MAGRUDER HALL

ADA ASSESSMENT & SURVEY

Re: ADA Accessibility Survey and Assessment – Magruder Hall

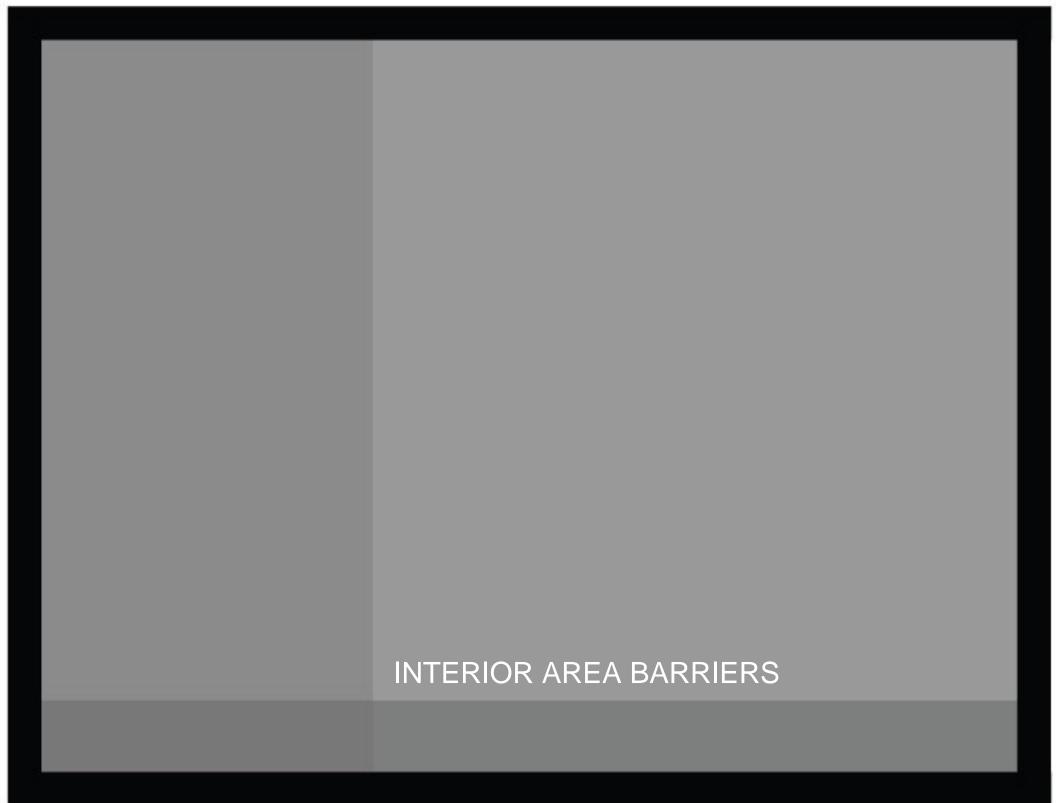
Barrier Type:	Stall Dimensions
Code References:	OSSC 1104.1 and ORS 447.233.2.(c)
Performance Sta	ndard: No Quantity: EACH As-built : 475
Barrier Description:	Accessible stall not min. 9' x 18"
Findings:	8' x 16'
Rec. Solution:	Restripe to provide accessible stall and access aisle
Rec. Solution: Barrier Severity:	
	2 Recommended Cost Est \$0.00 Facility Function: Public Status: Open
